*Technical Memo 2016-0715*  
*July 2016*

## Evaluation for Potential Unreasonable Impacts: Needmore Water, LLC, Well D Permit Application

Brian B. Hunt, P.G., and Brian A. Smith, Ph.D., P.G.

**Figure 1. Graphical presentation of drawdown versus time from the Needmore pumping alone at the Amos observation well (assuming Table 1 parameters). Note most of the drawdown occurs within the first year.**

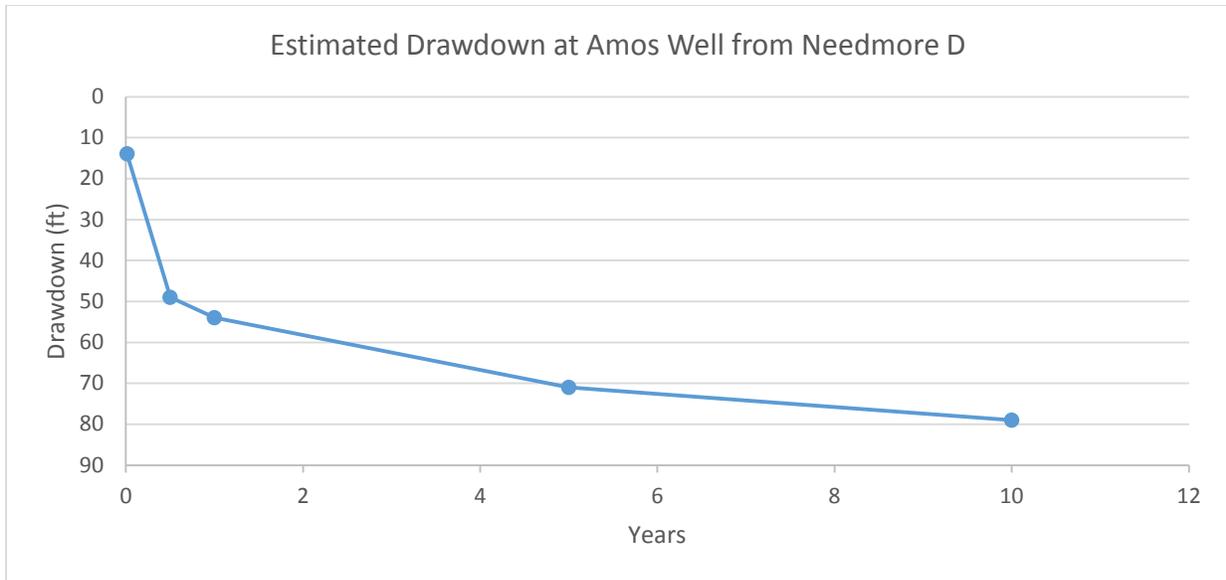
The WRGS (2016) report suggests minimal drawdown over time based on the applicant’s analysis of the Needmore Well D pumping data. AS staff estimated aquifer parameters from the data (**Table 1; Appendix A**) and present a range of drawdown from the pumping of Needmore Well D on nearby domestic-supply wells. The focus of this evaluation is on the potential drawdown to a domestic-supply well and a Hays Trinity Groundwater Conservation District monitor well known as the Amos Well. The well is located the Saddle Ridge subdivision located about 2 miles southwest of Needmore Well D (see map **Appendix A**). The Amos Well had a measureable response with recorded drawdown during the aquifer test of about 12 ft. AS staff reasonably assume that the water level response to pumping in the Amos Well is representative of wells in the northern area of Saddle Ridge subdivision.

Using the aquifer parameters derived from the aquifer test (**Table 1; Appendix A**), the AS staff estimate the additional drawdown from the Needmore pumping over time in **Figure 1**. For the evaluation, AS staff choose drawdown from pumping during a 7-year period. This period was chosen to be representative of a severe drought when little recharge occurs, and capture is constrained. The results of the estimated drawdown at the Amos Well due to Needmore pumping is about 75 ft after 7 years (**Figure 1**).

In order to estimate the potential for unreasonable impact from the Needmore pumping, the full range of water-level variability in the area of influence must be considered and accounted for in the evaluation (**Table 2**). This includes an accounting of projected drawdown attributed to factors independent of the proposed production including drought variability and existing and future local pumping (**Table 2**). Combined with this existing water level variability of 50 ft (**Table 2**), the total projected drawdown (76 ft) is about 126 ft. The estimated additional drawdown from the Needmore pumping could lower the water level (heads) below the top of the Middle Trinity Aquifer in the Saddle Ridge area. The additional drawdown also puts the water level within 20 feet of the pump in the Amos well.

**Figure 2. Potential Index Well Diagram and Compliance Levels**

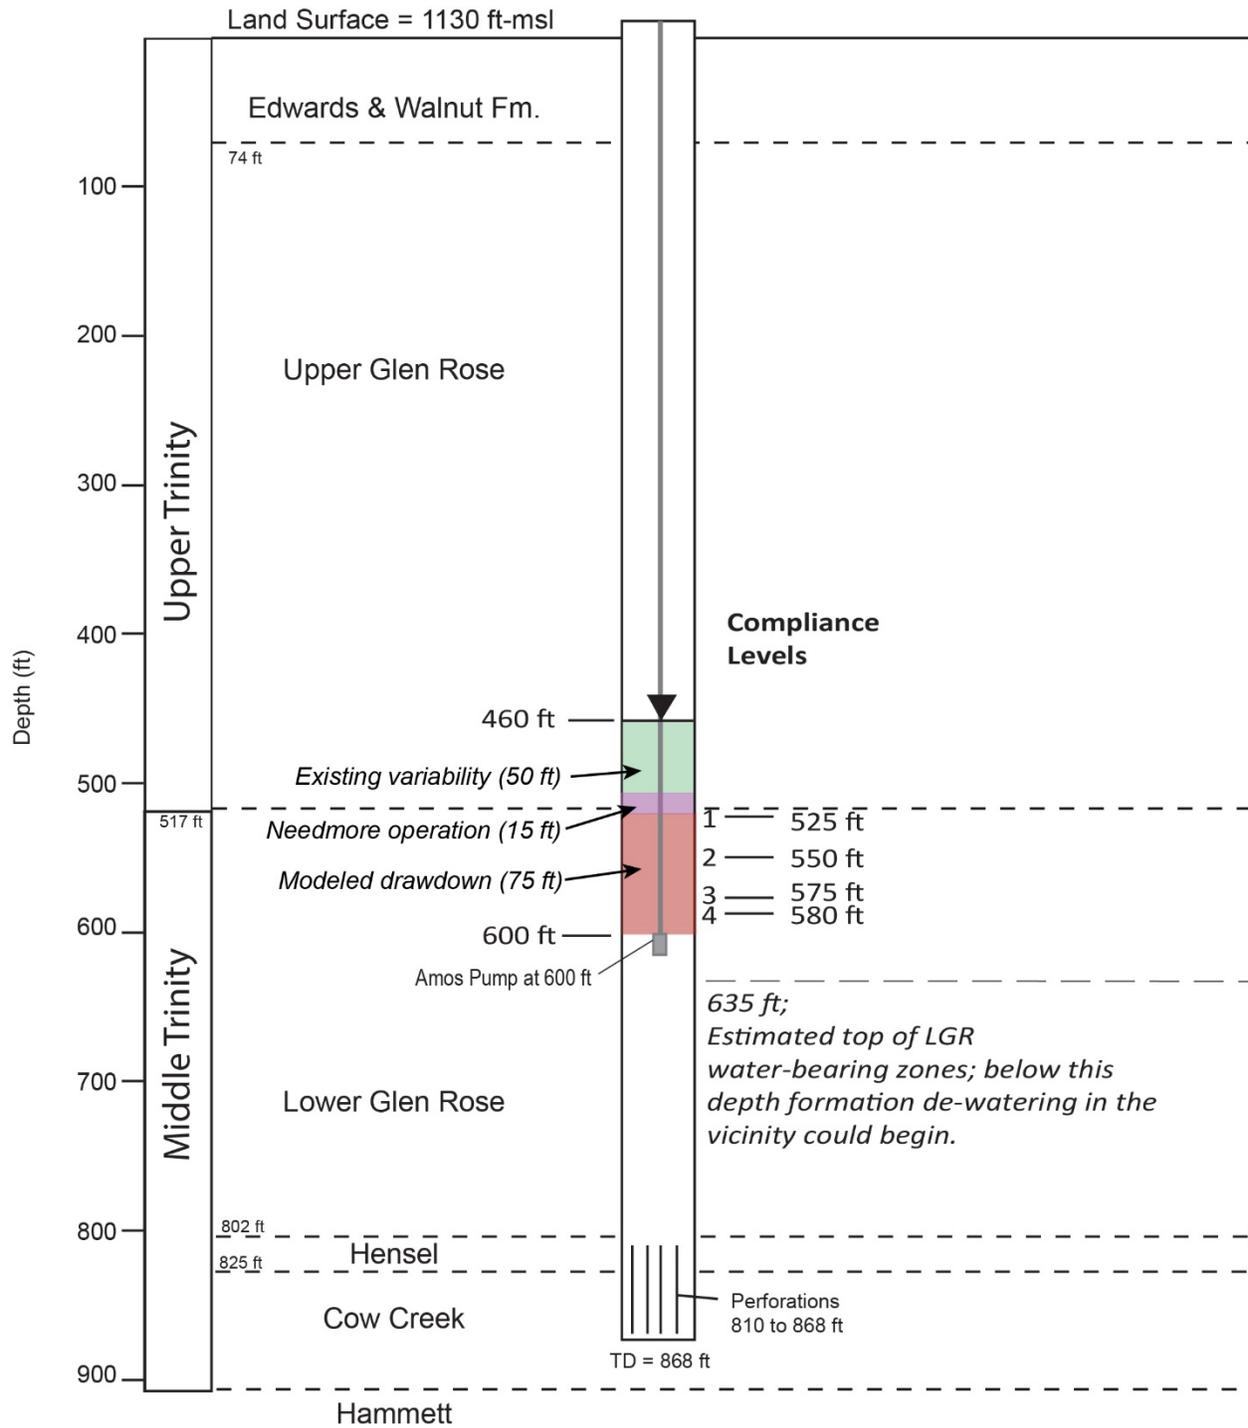
**Table 3** presents a summary of the specific compliance levels derived for the Amos Well. **Figure 2** is a graphical representation of the Amos Index Well and the corresponding compliance levels. Compliance levels were set after considering natural water level variability (Table 2; 50 ft) and also the observed short-term operational effects of pumping from the Needmore Well (~15 ft). Thus, this allows for up to about 65 ft of variability below the average water level before crossing the first compliance level threshold. **Figure 3** is a conceptual diagram showing how each compliance level is distributed over depth and time.
